WCP	Description	WCP SS Flip	ped Gearbox	V2 (SingleSpeed, 2 Stages)	
		Dwg No	Web-WCP-0496			
		Project	FIRST Robotics - FRC 1/19/2023 ALL DIMENSIONS AF		Sheet 1 of 1	
		Release			E IN INCHES [MM].

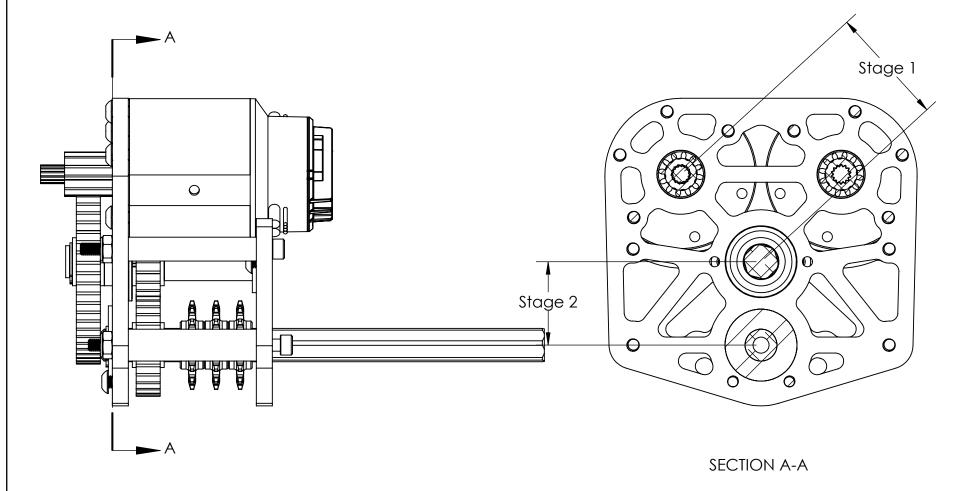
- (1) Dimension A updated from 1.875" to 2.000"
- (2) Dimension B updated from 1.4375" to 1.500"
- (3) Dimension C updated from 4.375" to 4.000"

- (1) Gearbox 1st Stage changed from 72T to 74T c-c, and 2nd Stage changed from 48T to 52T c-c
- (2) Gear teeth sum calculated by adding the tooth count for both gears together [Ex: 62 + 12 = 74]
- (3) Gears not included in BOM
